Modification Changes
- Addition of louvers to podium of the mezzanine level and level 1
- Airlock reconfiguration

Project
WATERLOO METRO QUARTER DEVELOPMENT

Sheet title
General Arrangement Plan
Level 16-22 Plan

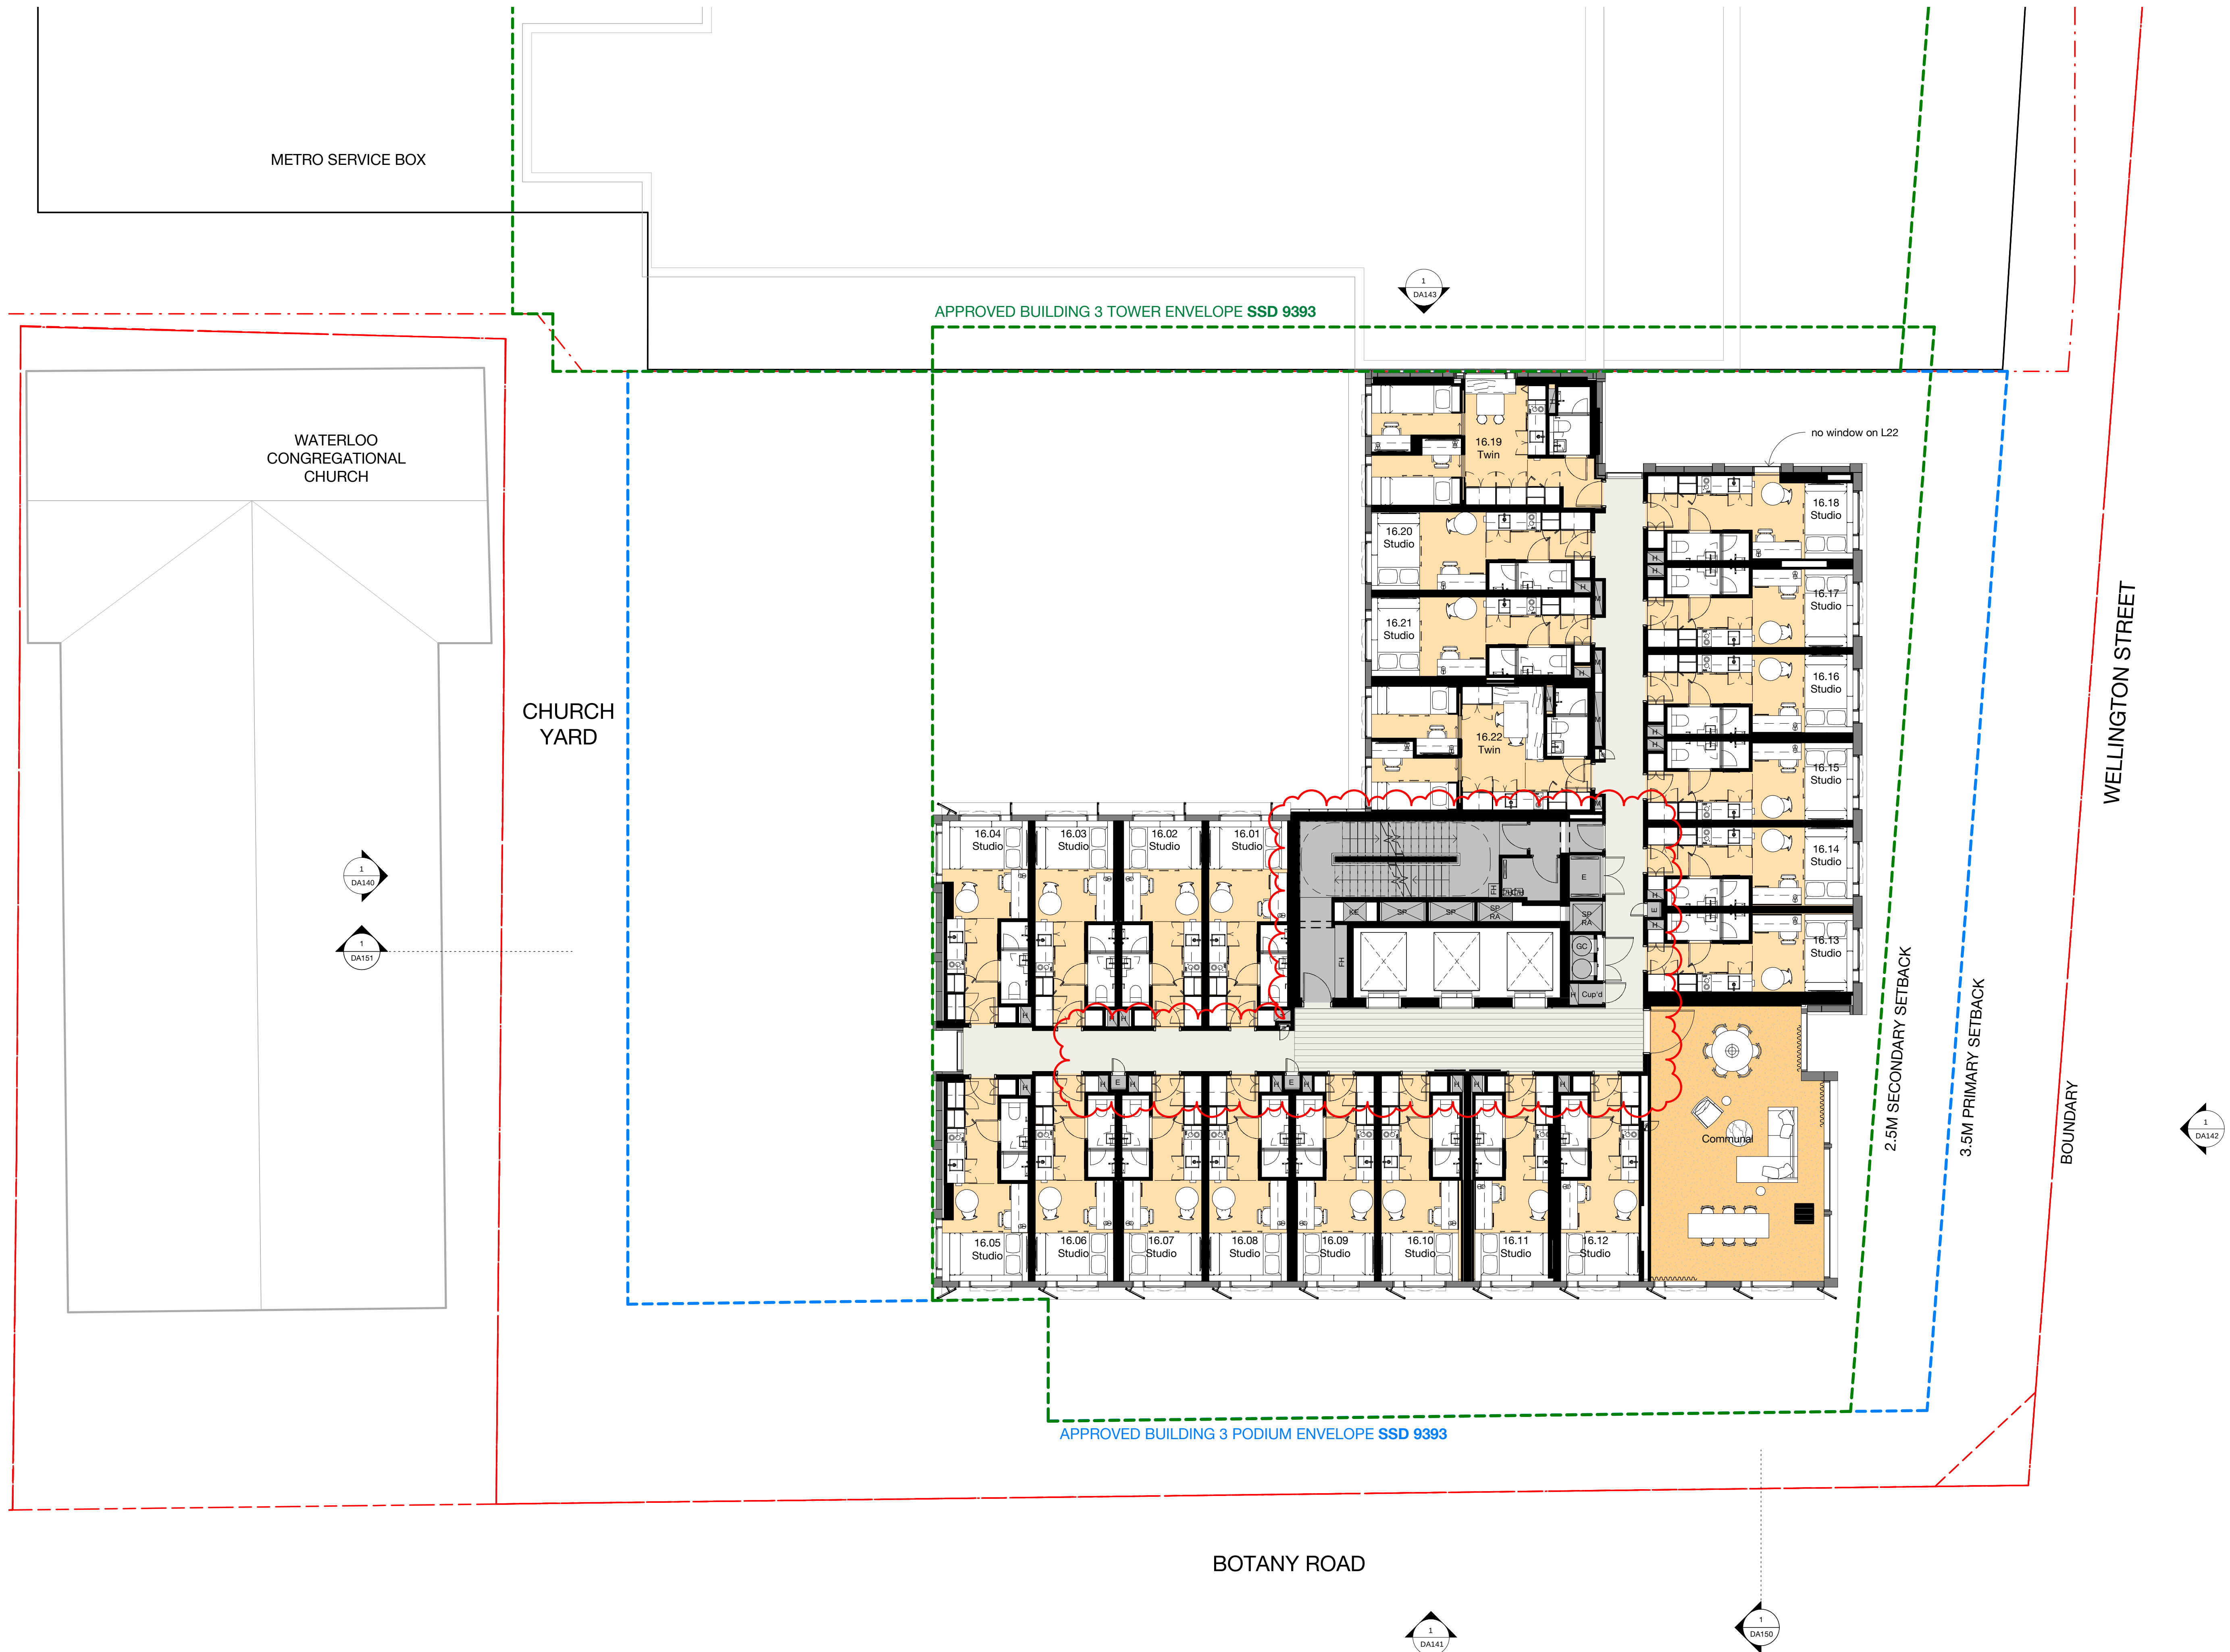
- Modification Changes
- Student Accommodation - reconfiguration to the core and services
 - Additional services risers

Sheet title
General Arrangement Plan
Level 23 Plan

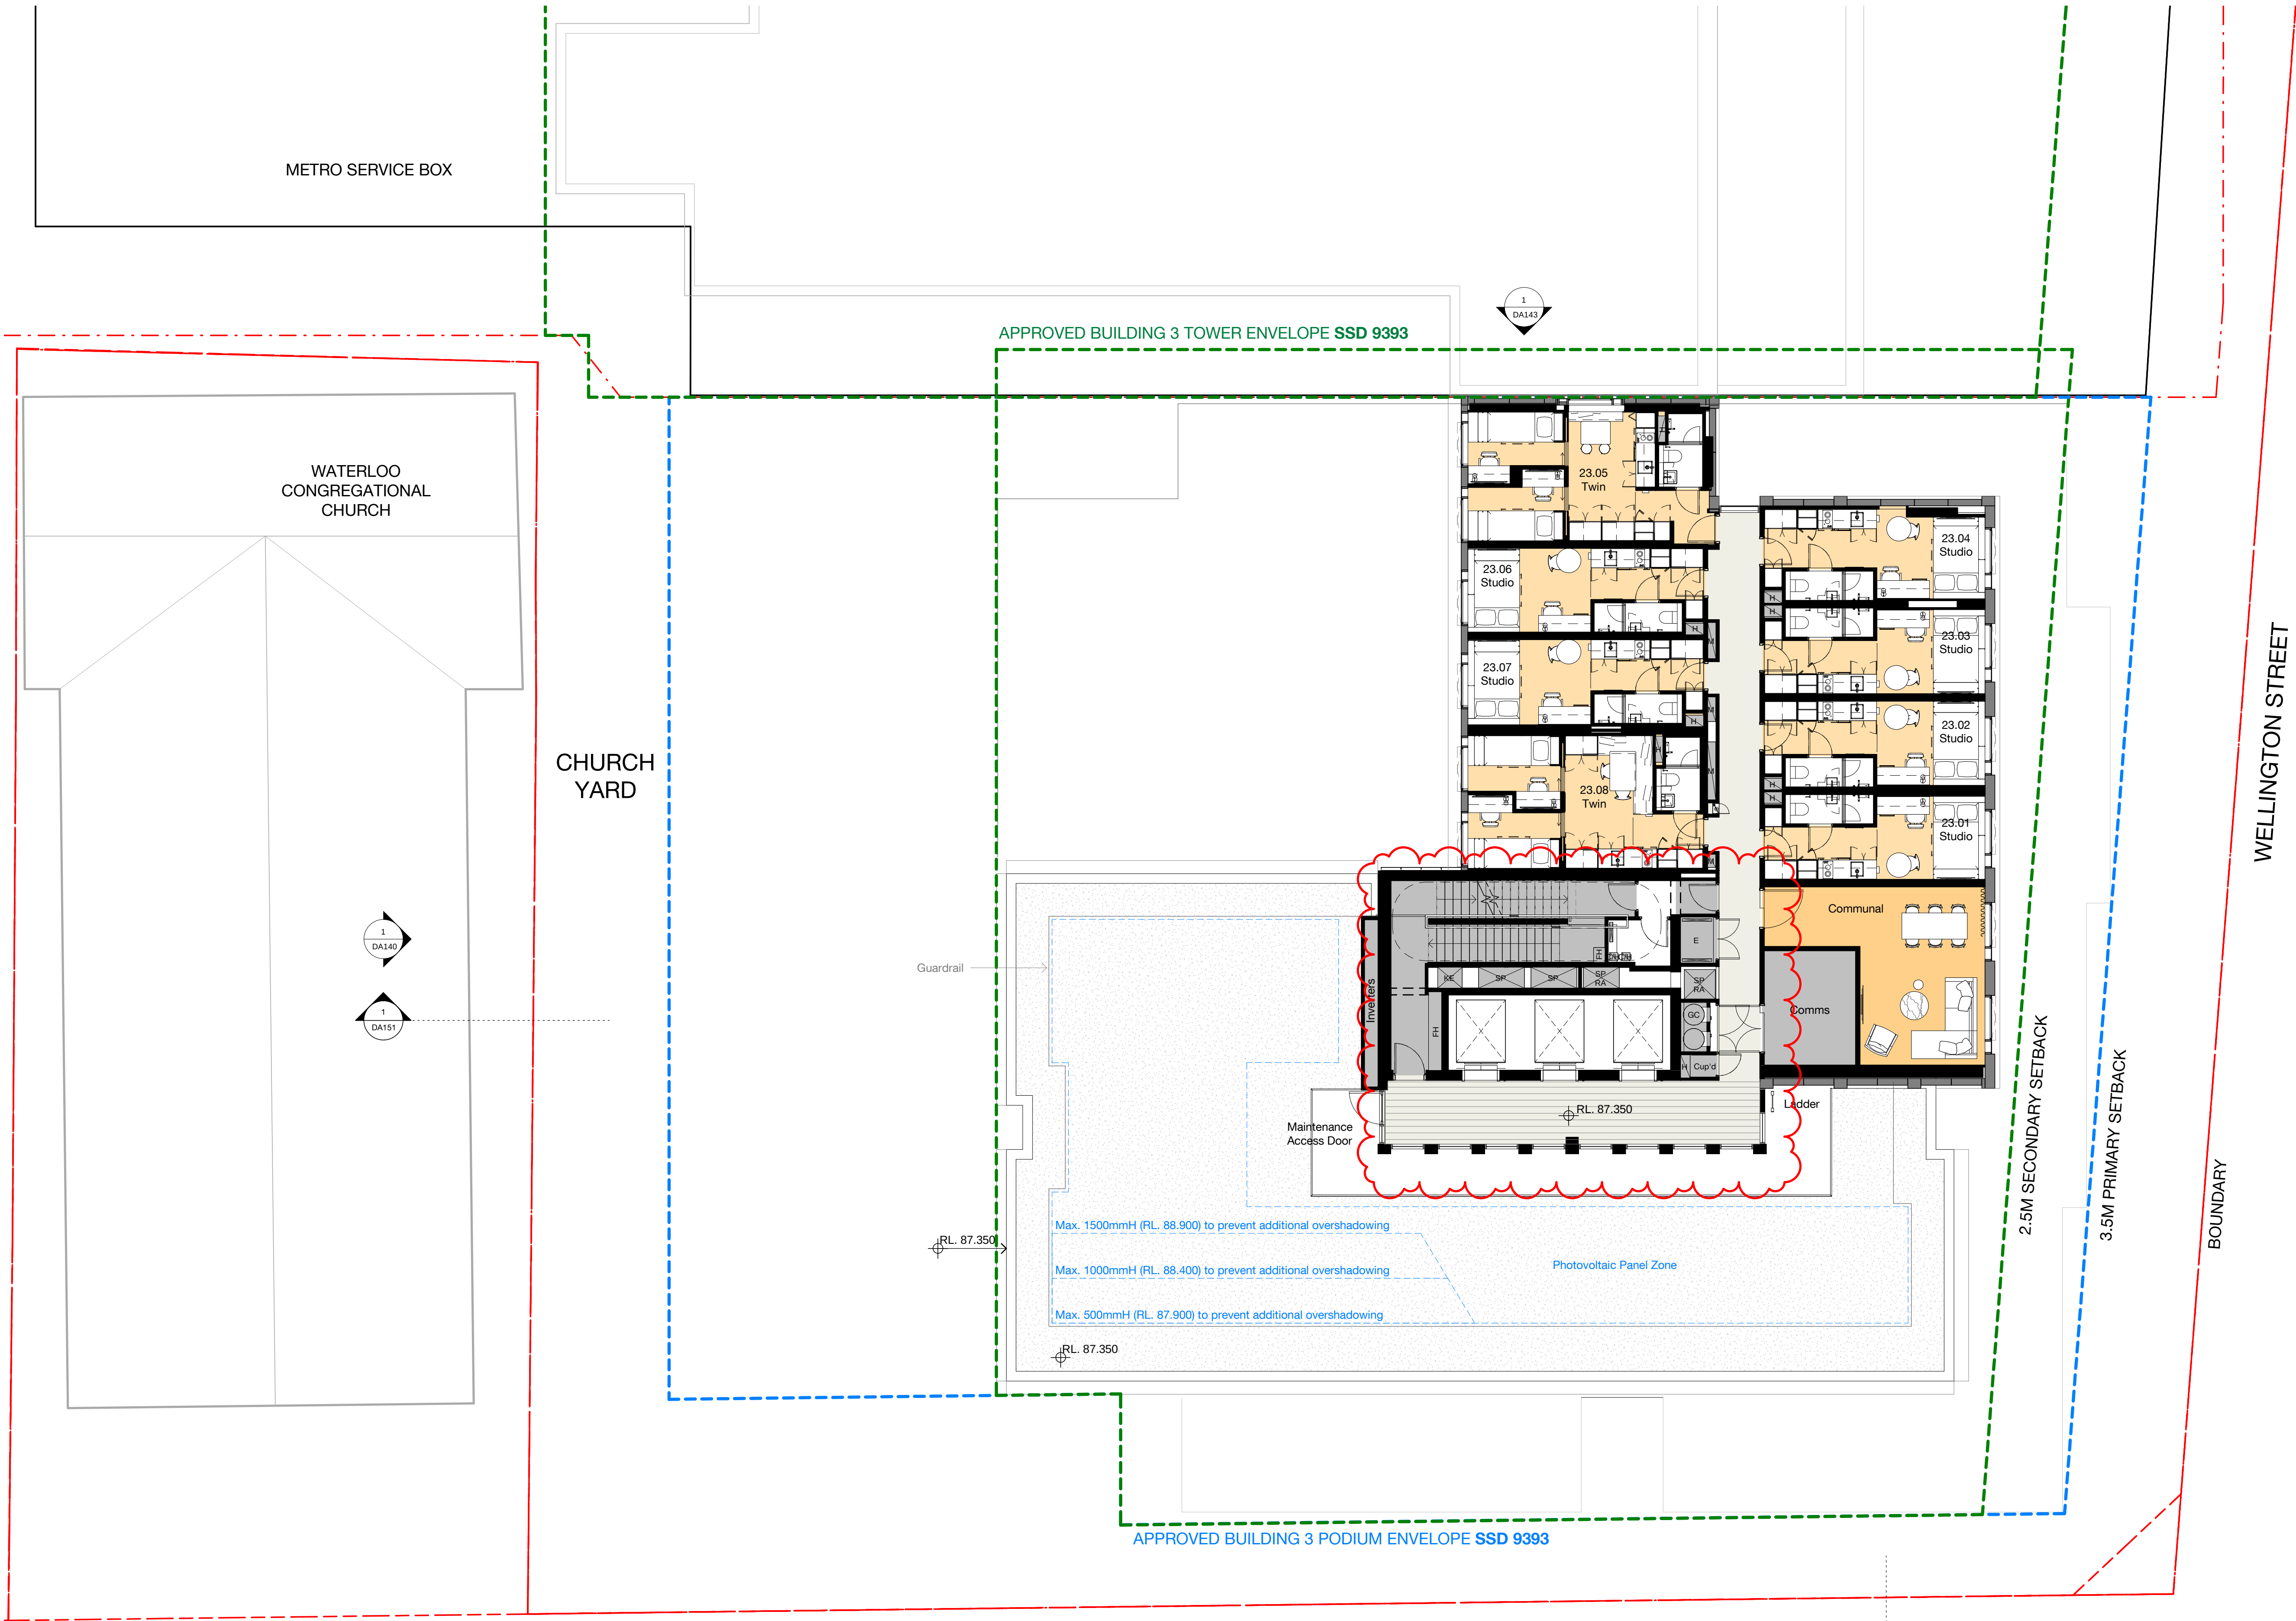
Modification Changes
- Student Accommodation - reconfiguration to the core and services

Sheet title
General Arrangement Plan
Level 24 (Plant) Plan

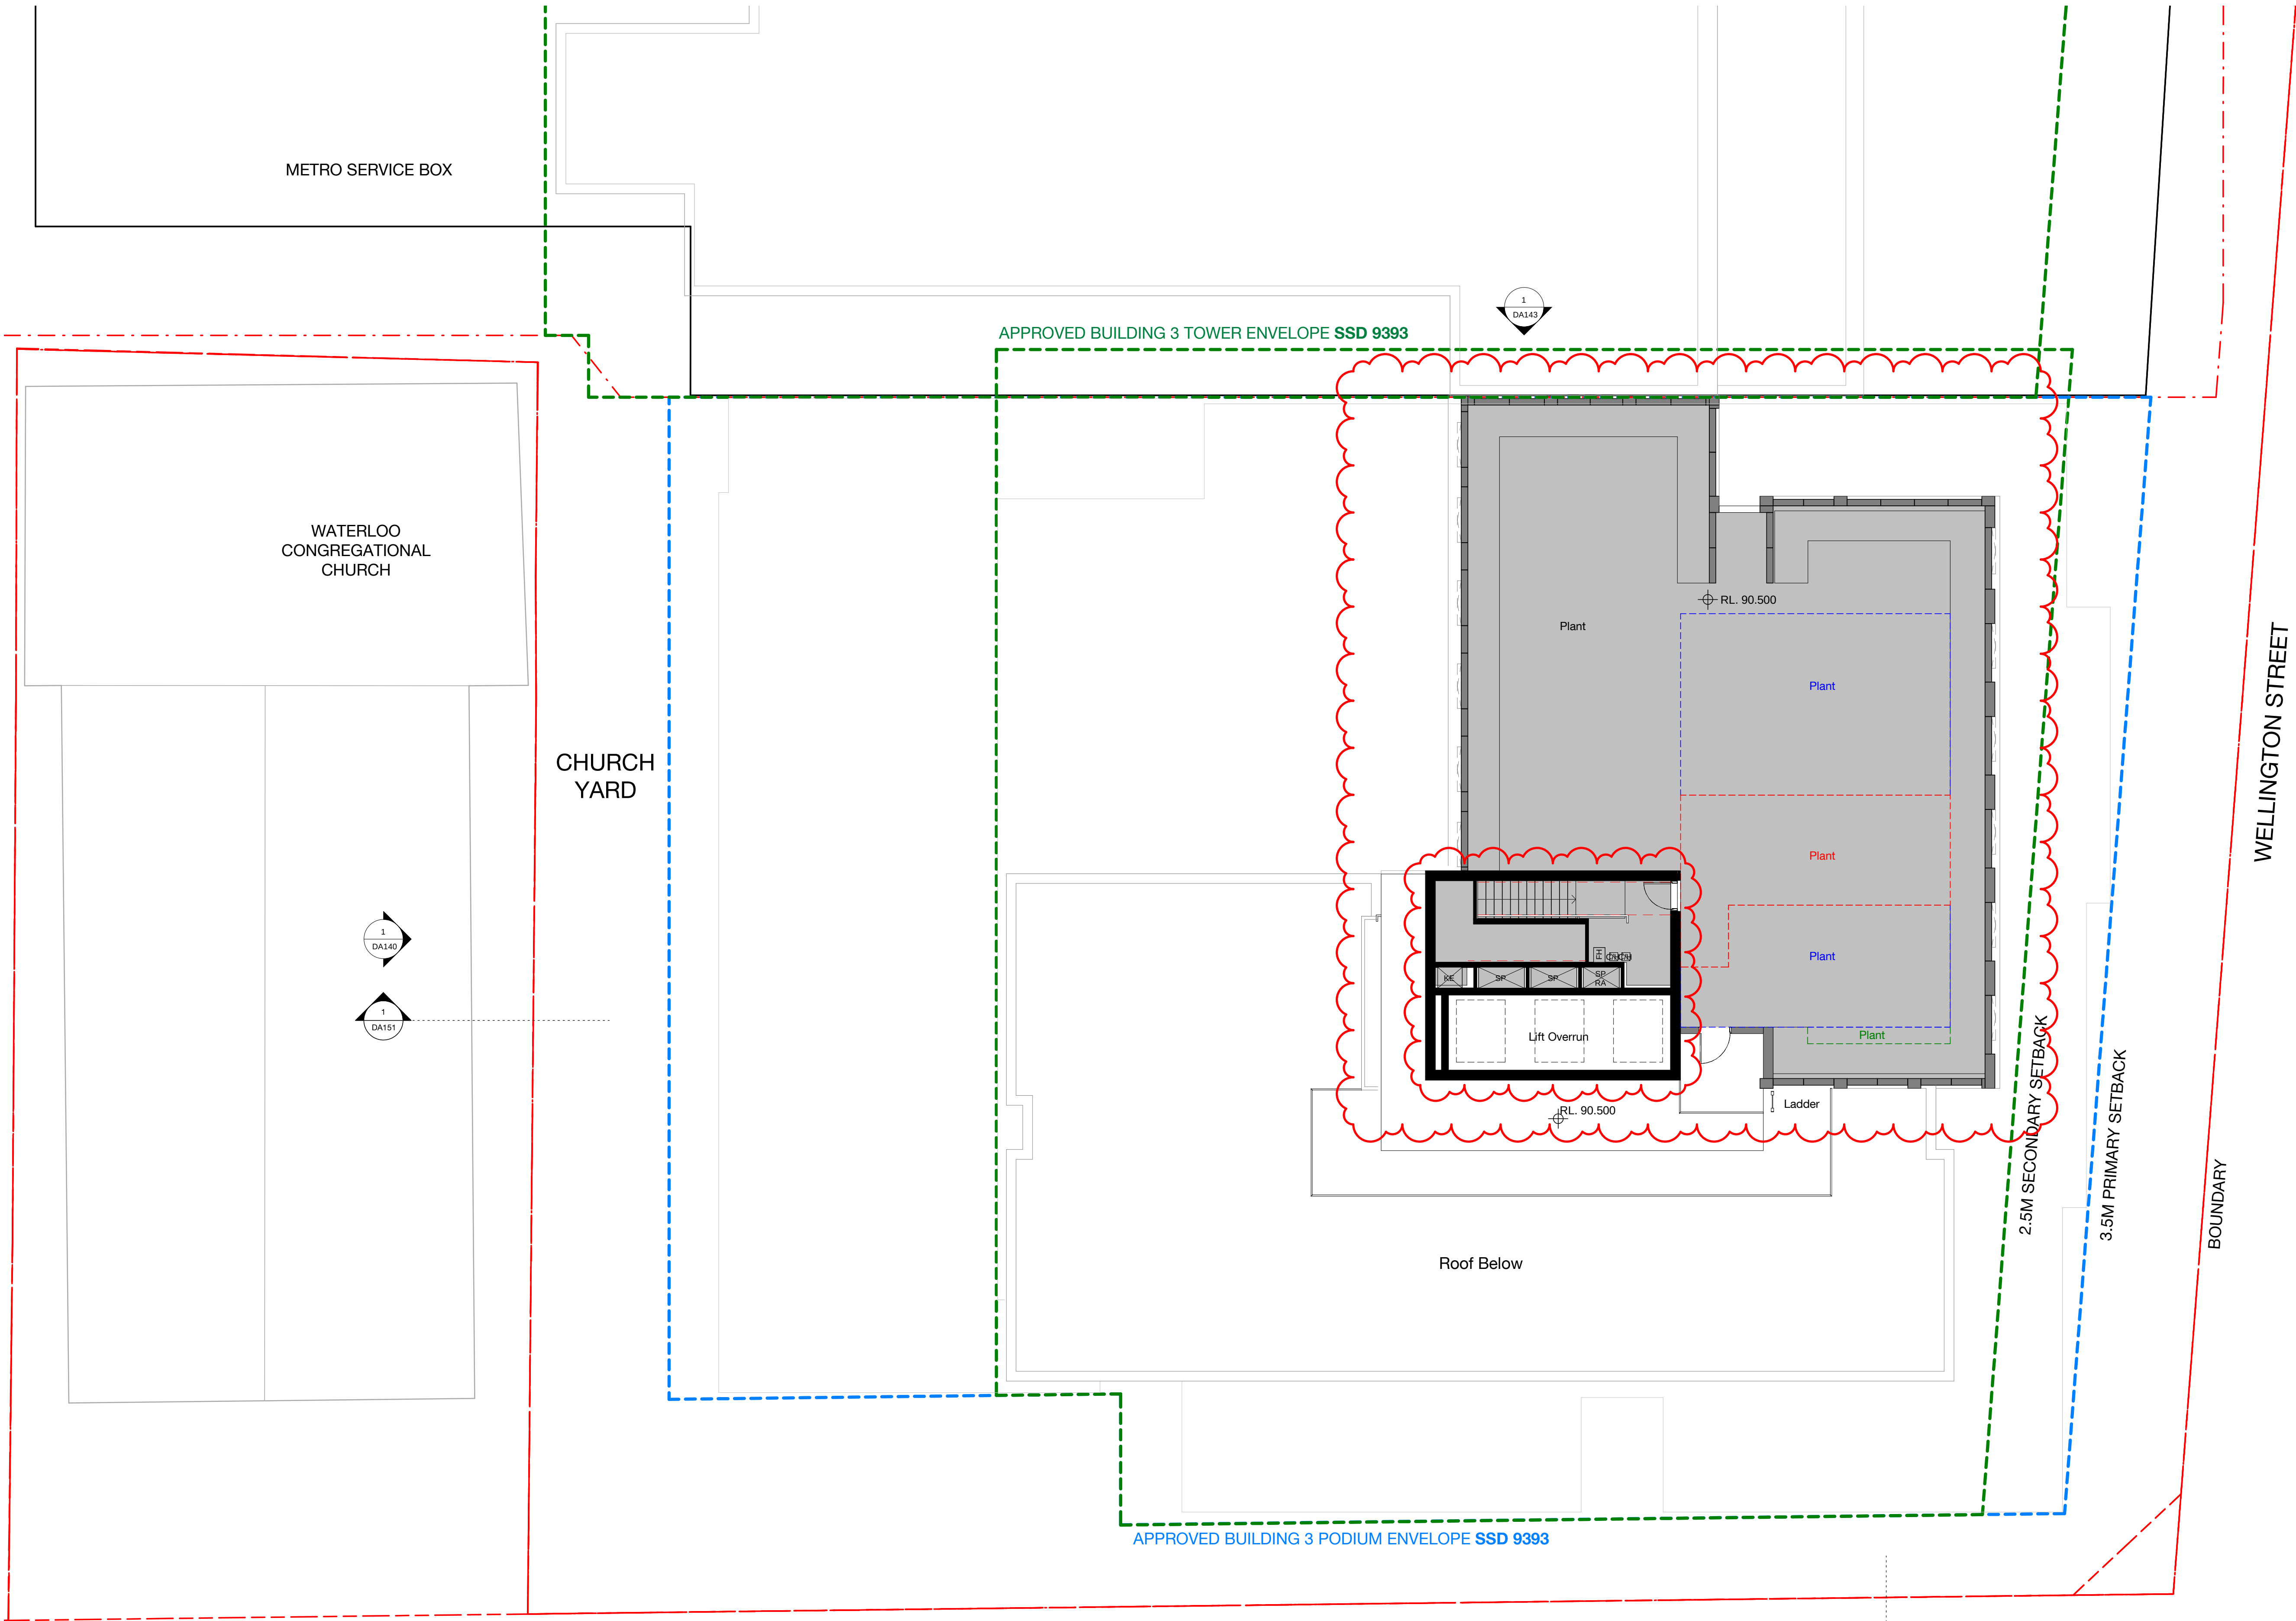
- Modification Changes
- Student Accommodation - reconfiguration to the core and services
 - Roof plant zone
